L-2010-131
10 CFR 50.90

Re: Turkey Point Units 3 and 4
Docket Nos. 50-250 and 50-251
Response to 5/28/2010 Request for Additional Information (RAI) Regarding
Alternative Source Term (AST) License Amendment Request (LAR) 196
(TAC NOS. ME1624 and ME1625)

Response to 5/28/2010 Request for Additional Information (RAI) Regarding
Alternative Source Term (AST) License Amendment Request (LAR) 196

Turkey Point "MSI QA File" - 2006
Alpha minus Bravo dT (°F) @ 60 Meters
and
Alpha minus Bravo dT (°F) @ 10 Meters

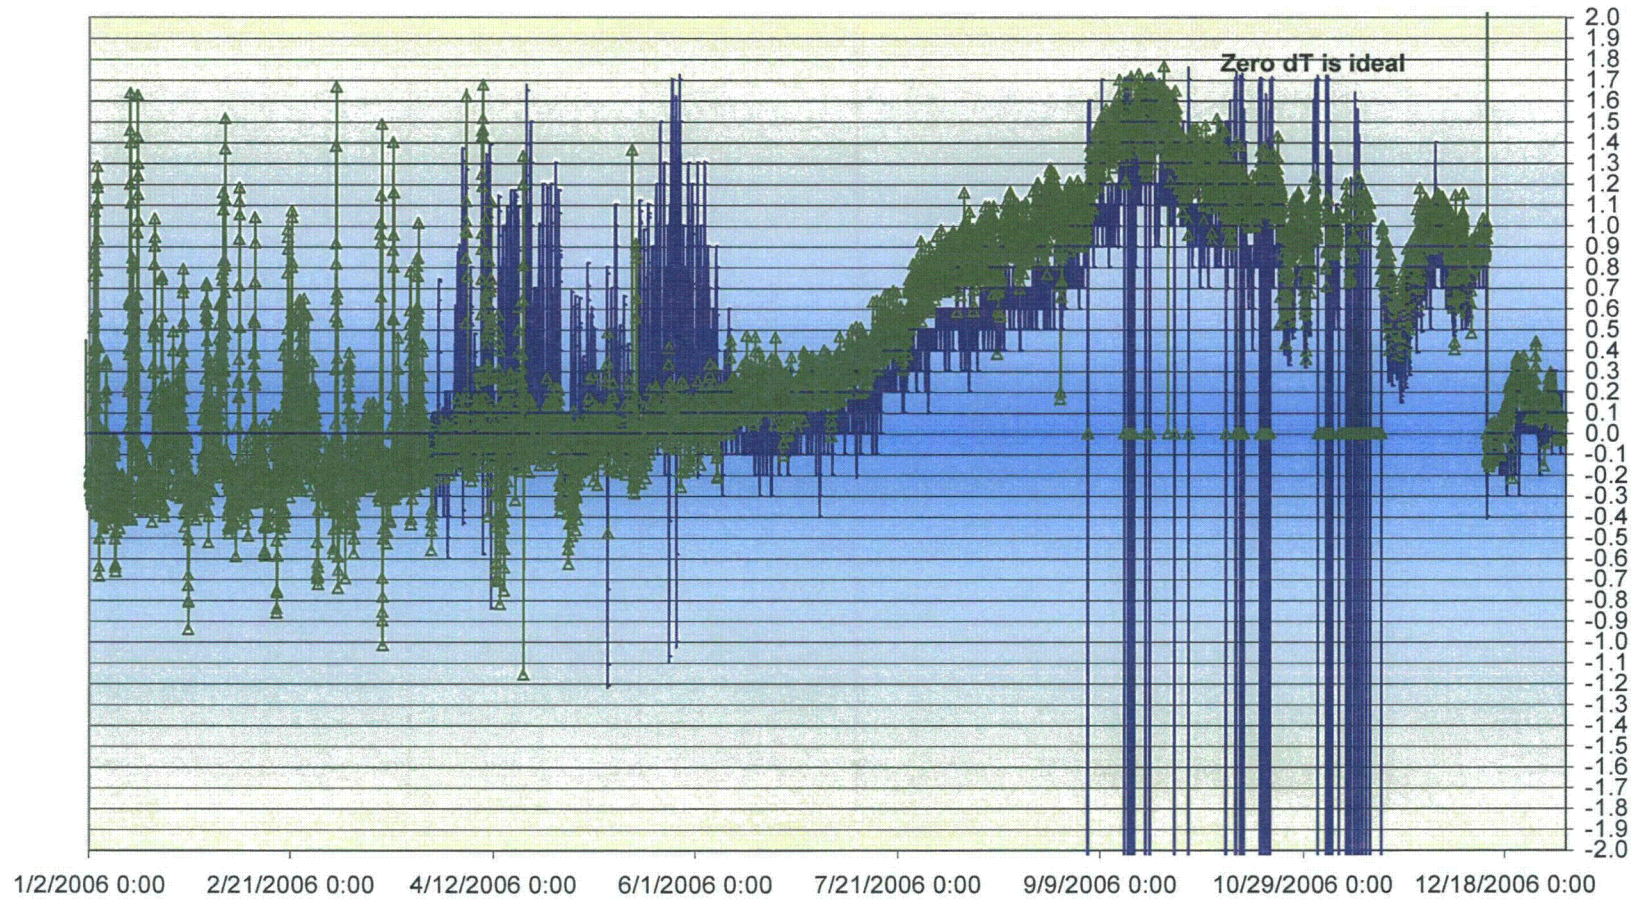
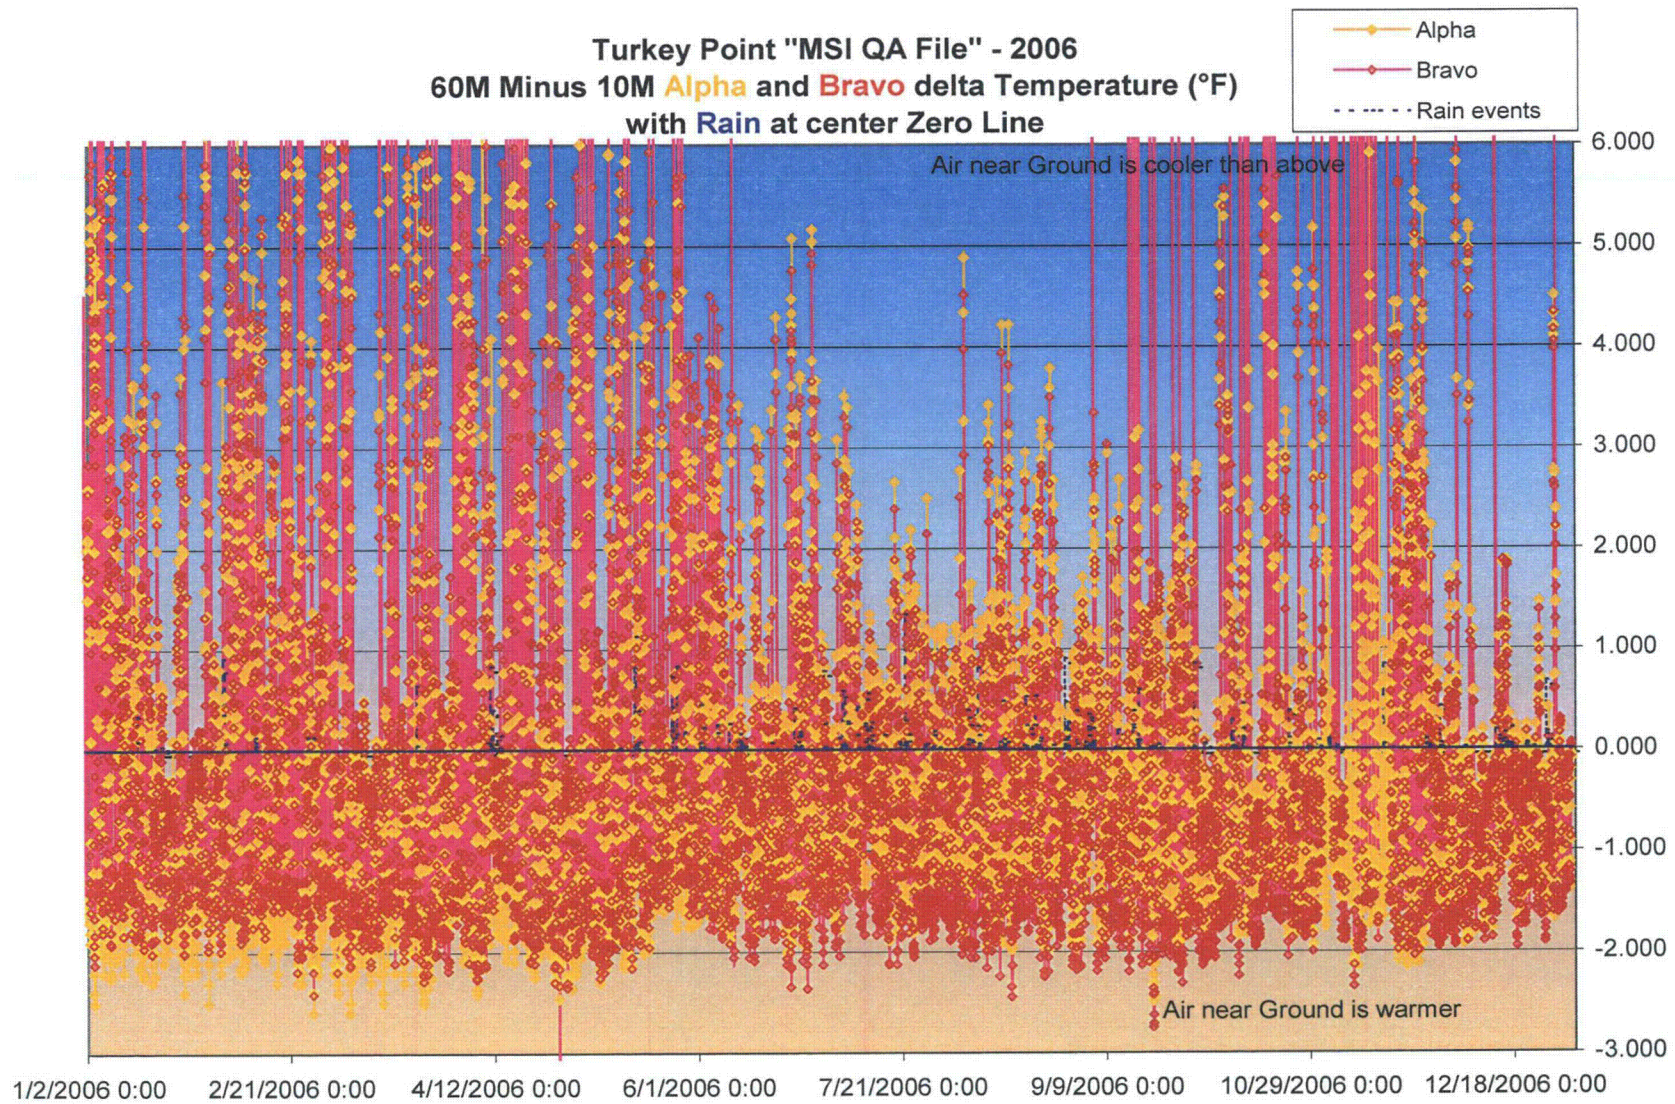
3. *Page 12 of the enclosure to the April 14, 2010 response states that in some cases, substitutions were made when there was a considerable amount of invalid data from the primary measurement trains. Were substitutions made for infrequent random occurrences of a few hours duration? Does the discussion at the top of page 13 summarize all of the substitutions? Were the temperature difference data in the computer input files for 2003, the second half of 2004, the second half of 2005, the last three quarters of 2006, and 2007, other than August through October, inclusive, essentially all measured only on the primary tower?*

Q3-2006		A-B Delta-T @ 60M & 10M	Unknown	NAI review of this plot indicates that the trend in 10M A-B delta-tracks a similar trend in 60M A-B delta T, so any impact will be offset. This is confirmed by review of the plot on next page (60M – 10M Alpha vs. Bravo Delta Temperature) which shows no bias or trend in TA60M-10M or TB60M-TB10M. No further investigation needed.	NAI Comment: Review plot below for clear trend in A-B delta-T during the third quarter.
